Appl. № 10/708,191
Amdt. dated 6 April 2006
Reply to Office Action of 28 December 2005

Amendments to the Drawings:

REMARKS/ARGUMENTS

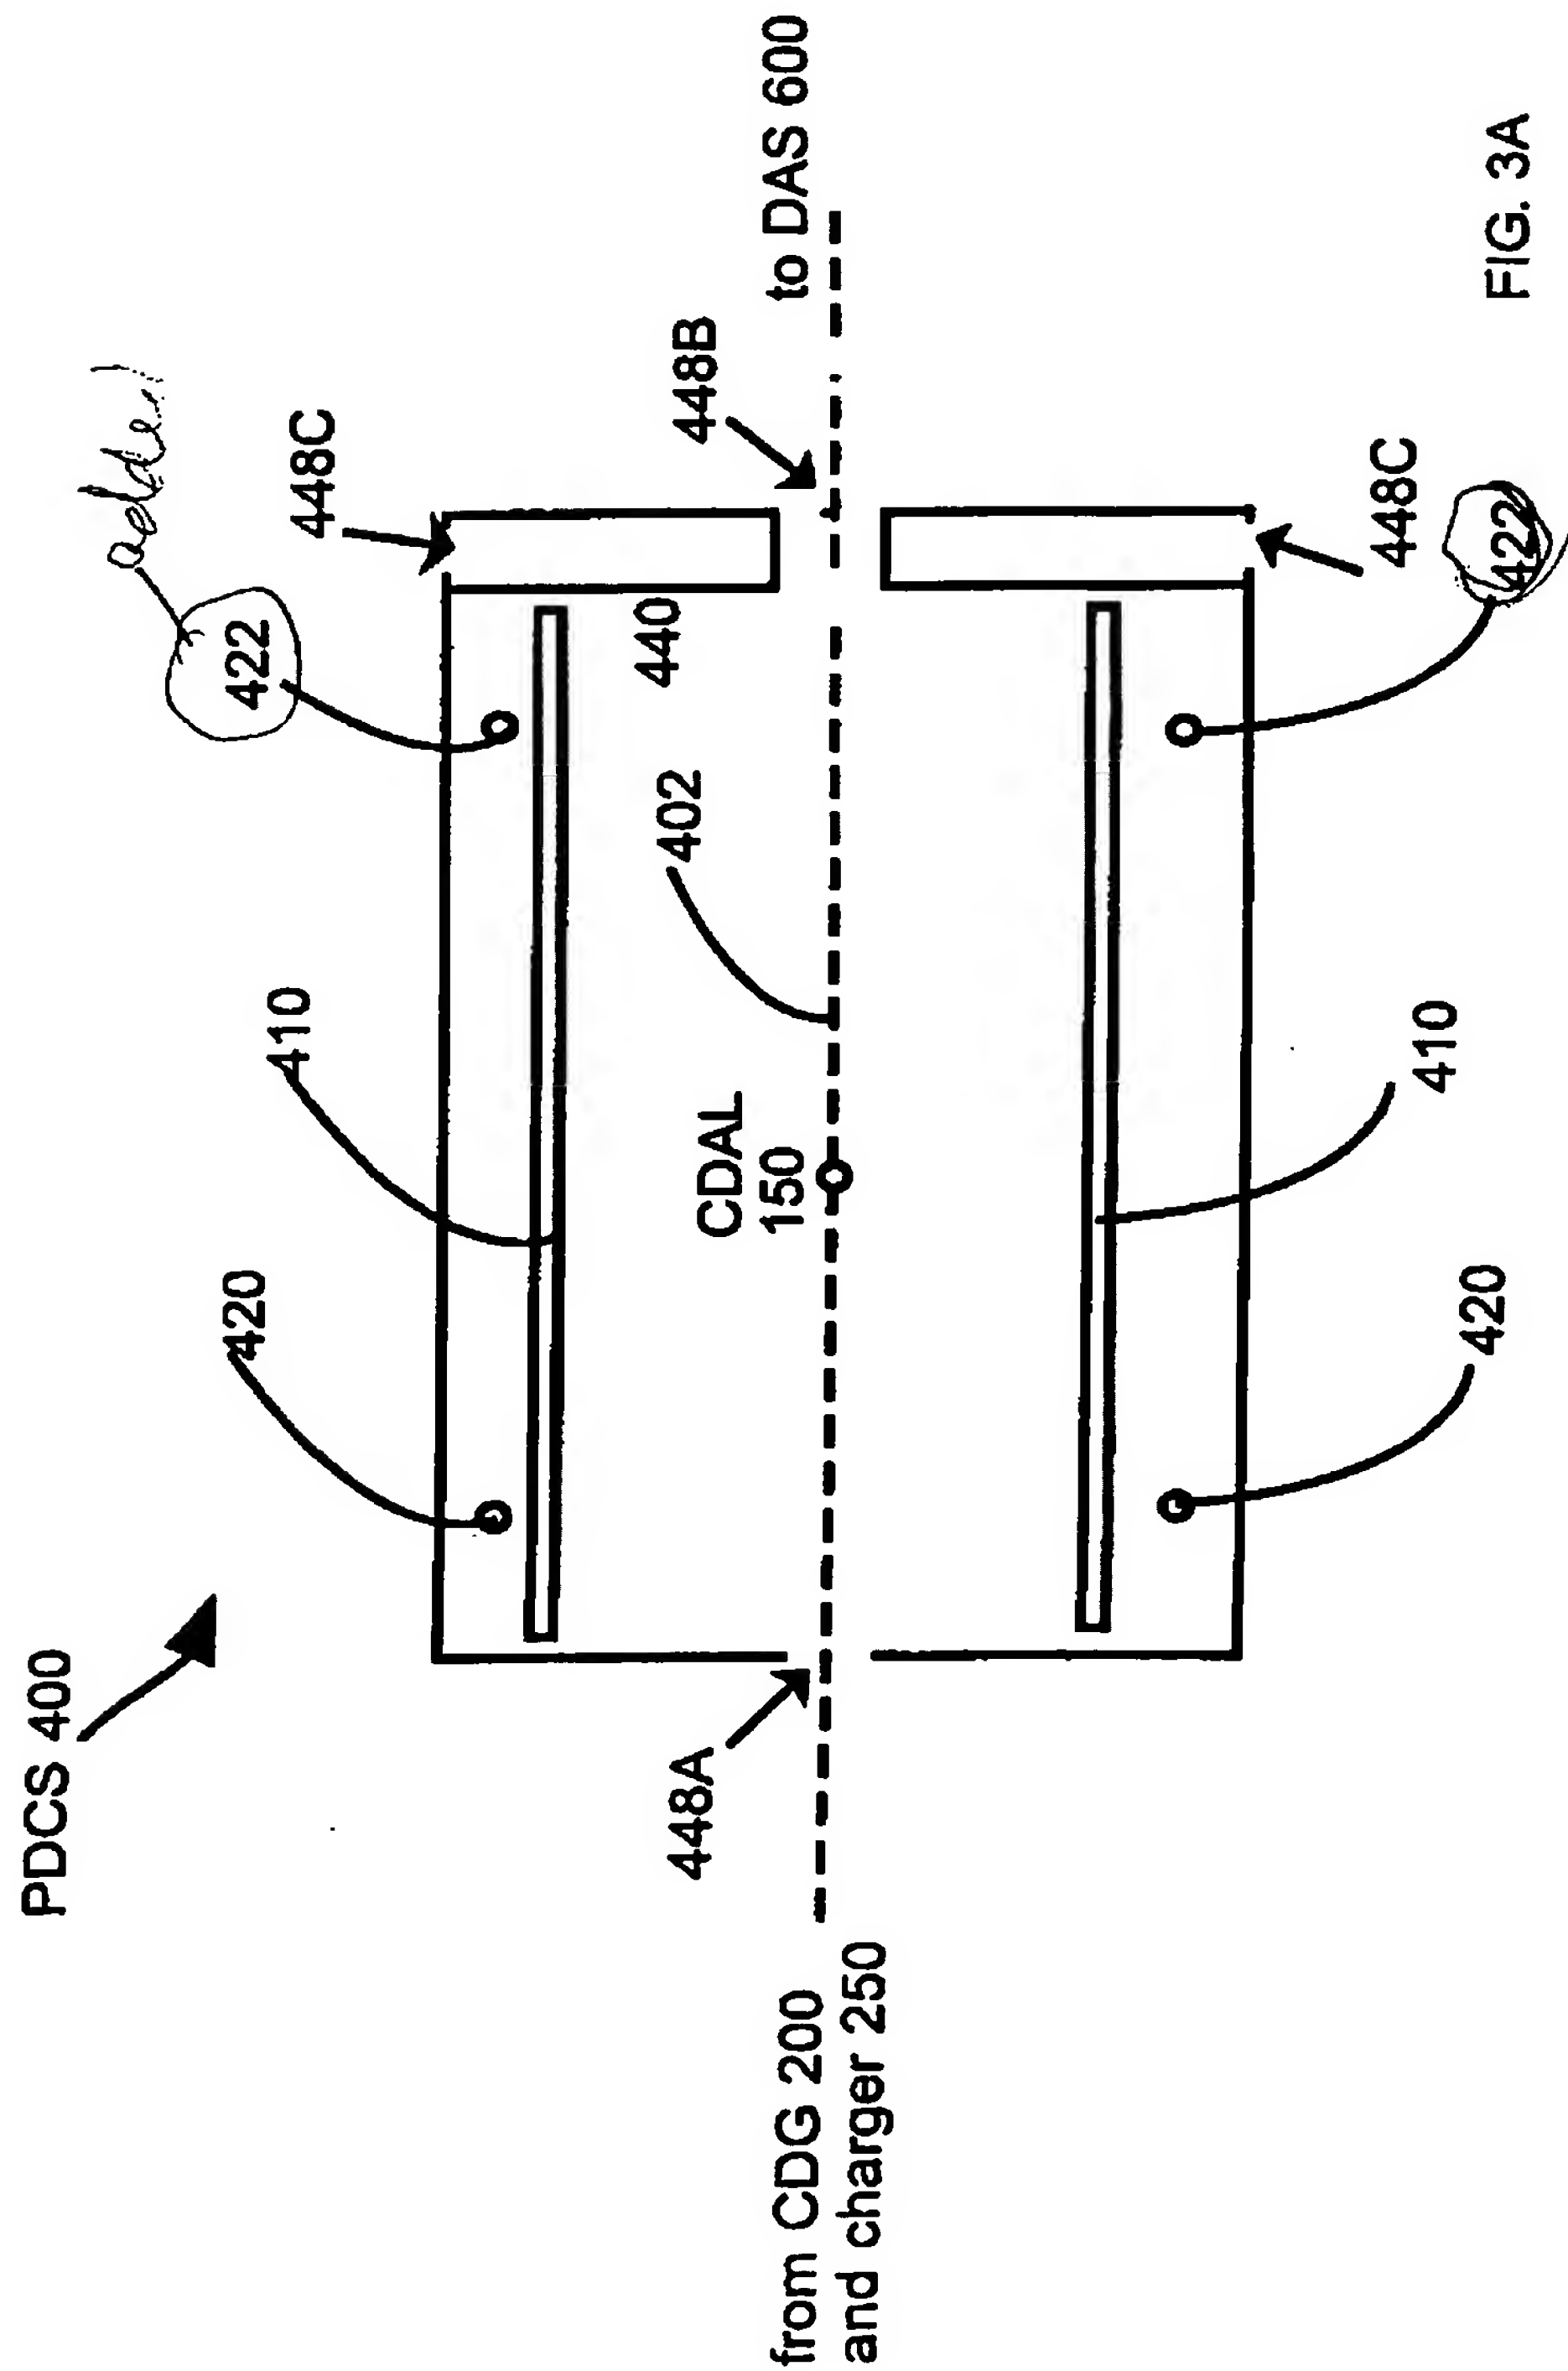
The attached sheet of drawings includes changes to Fig. 2. This sheet replaces the original sheet. In Figure 2, previously omitted reference number 820 has been added.

In paragraph [0054] there is reference to "structure-switching signaling aptamer 820" but it is not shown in the referenced Figure 2. Figure 2 has been corrected.

FIG. 3E

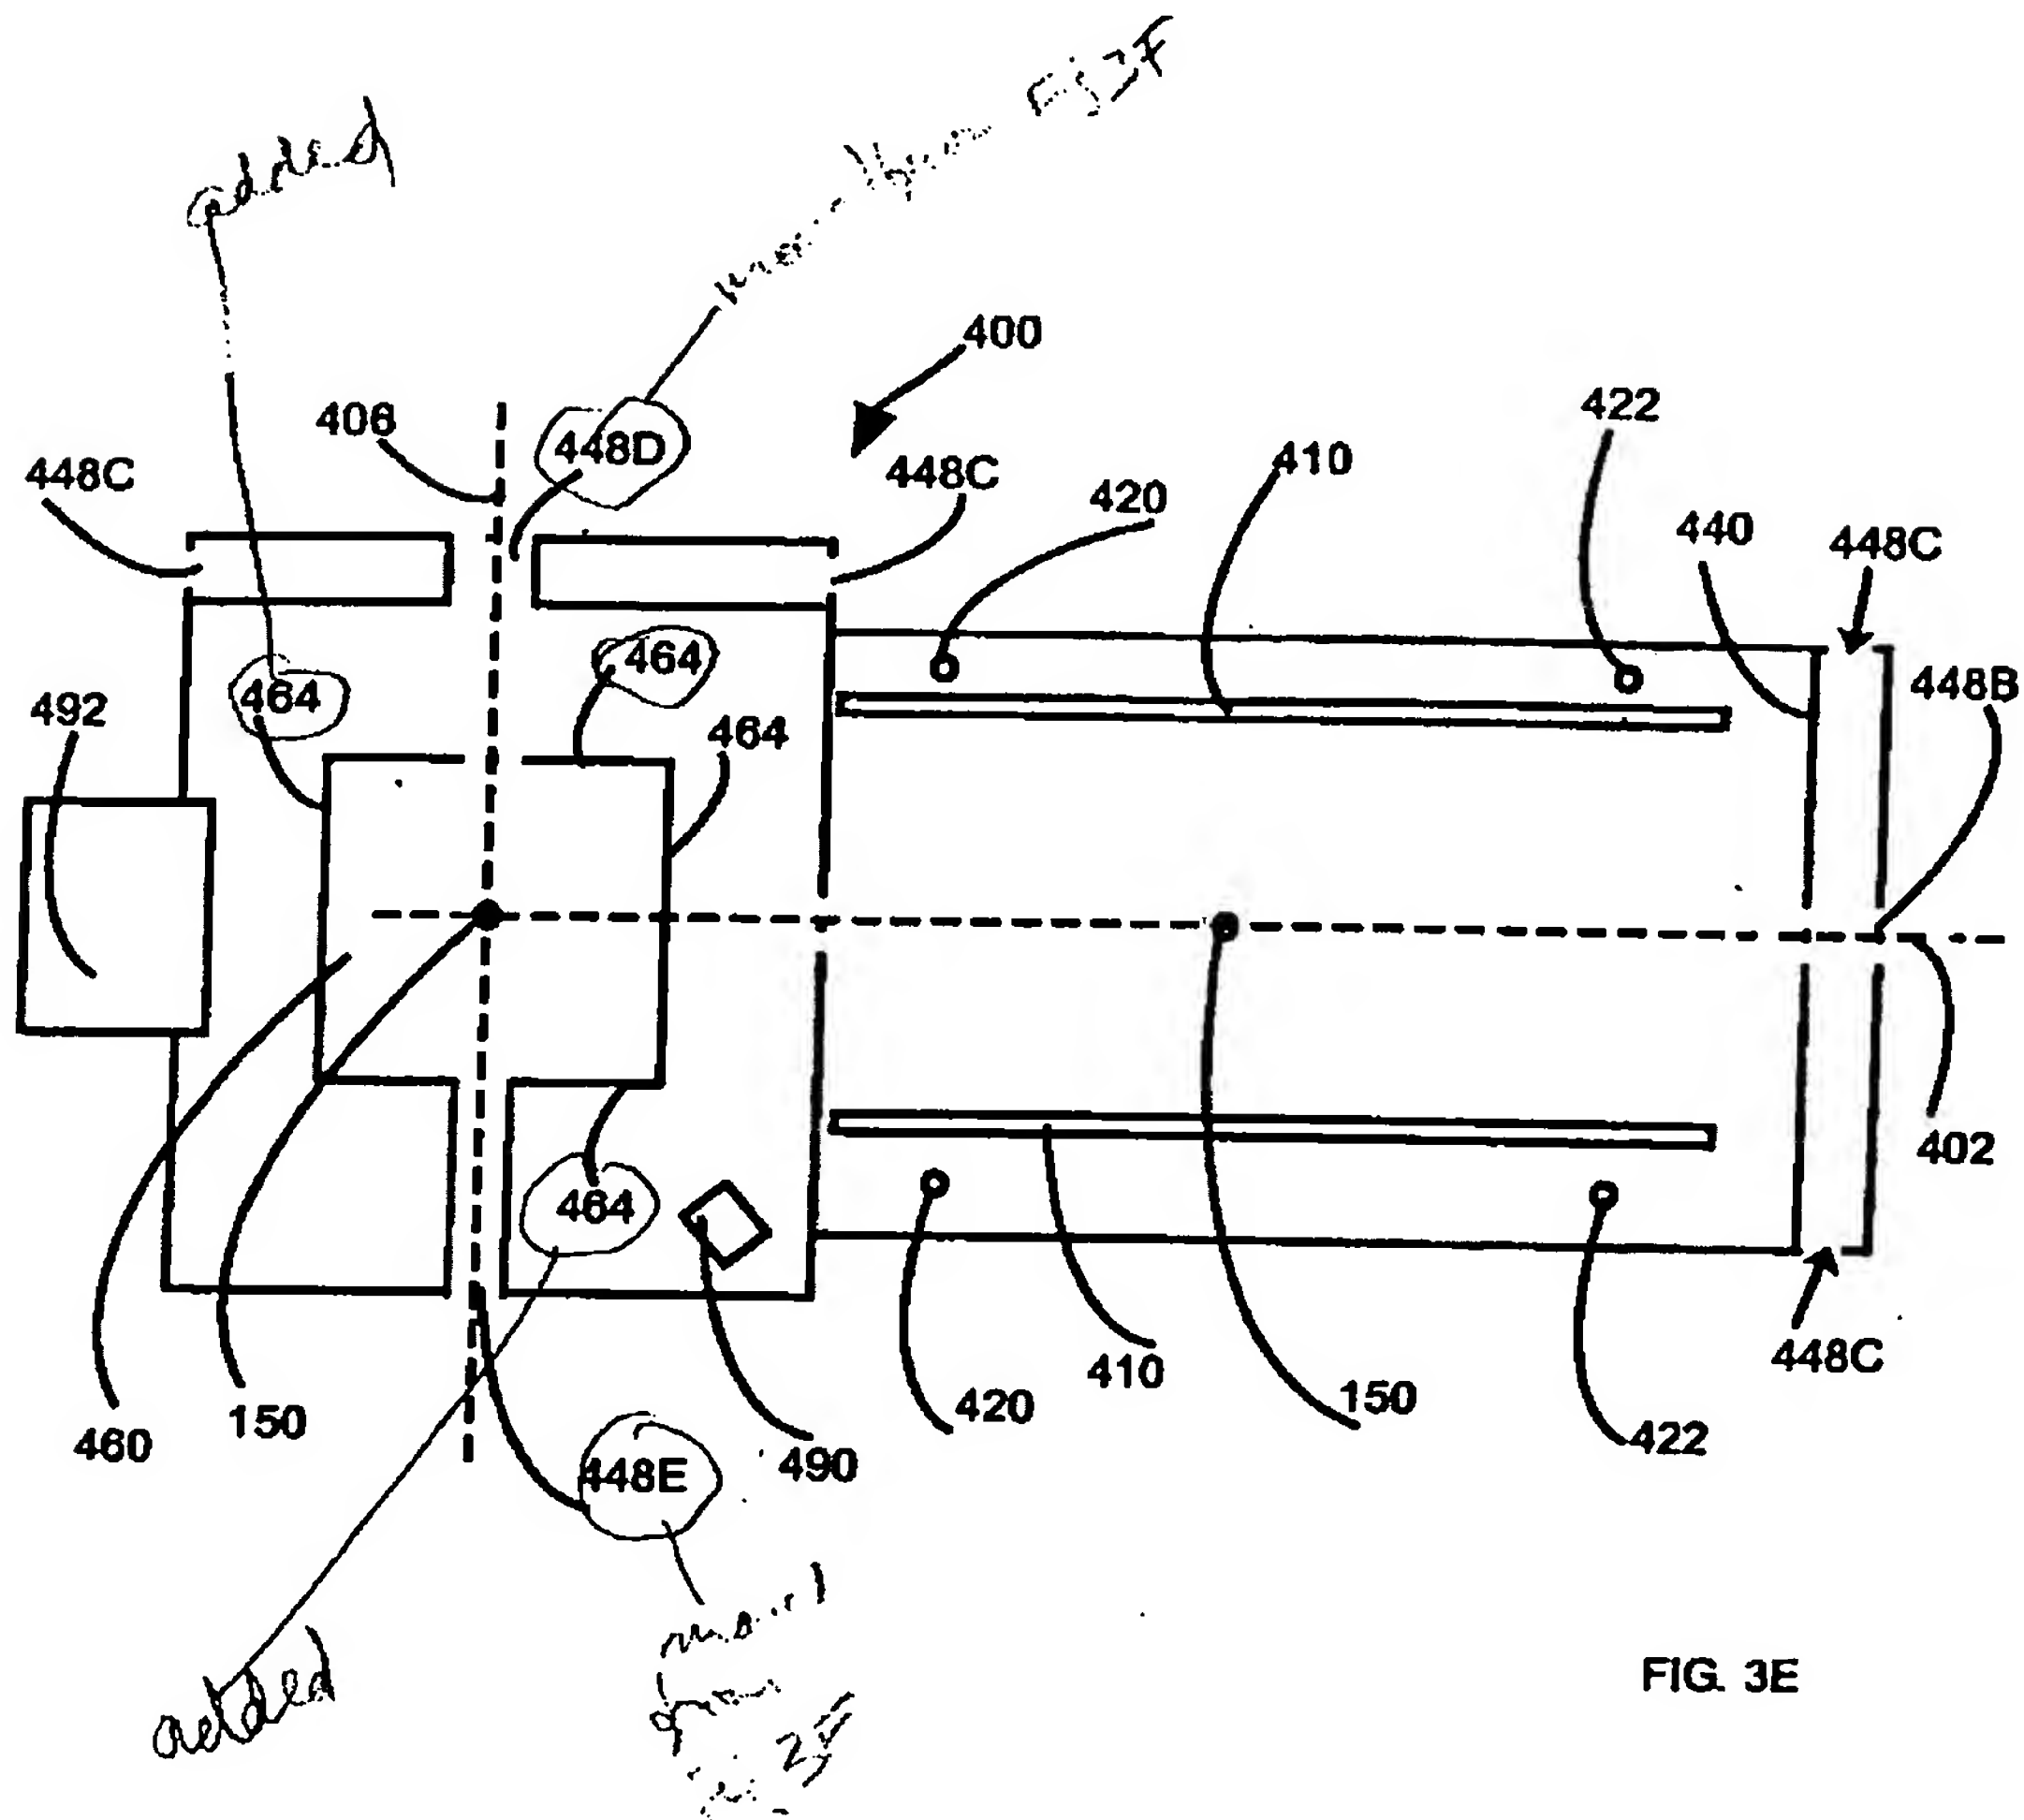
The attached Replacement Sheet showing FIG. 3E adds several reference numerals referred to in the specification and not previously listed and moves several reference numerals from redundant FIG. 3F. Specifically Reference numeral 464 is added in several locations and Reference numerals 448D & E are moved from deleted FIG. 3F.

Paragraph [0058] references "CEDB electrodes 464" as disclosed in Figure 3E but it is not found in Figure 3E. The label has been added to the figure and the text has been modified to more clearly state the invention.

Reference numbers 448D & 448E are displayed in Figures 3E & 3F but not described in the specification. Figure 3F is deleted along with mention of figure 3F in the specification. Figure 3E is corrected to cover the removal of an now unnecessary figure.
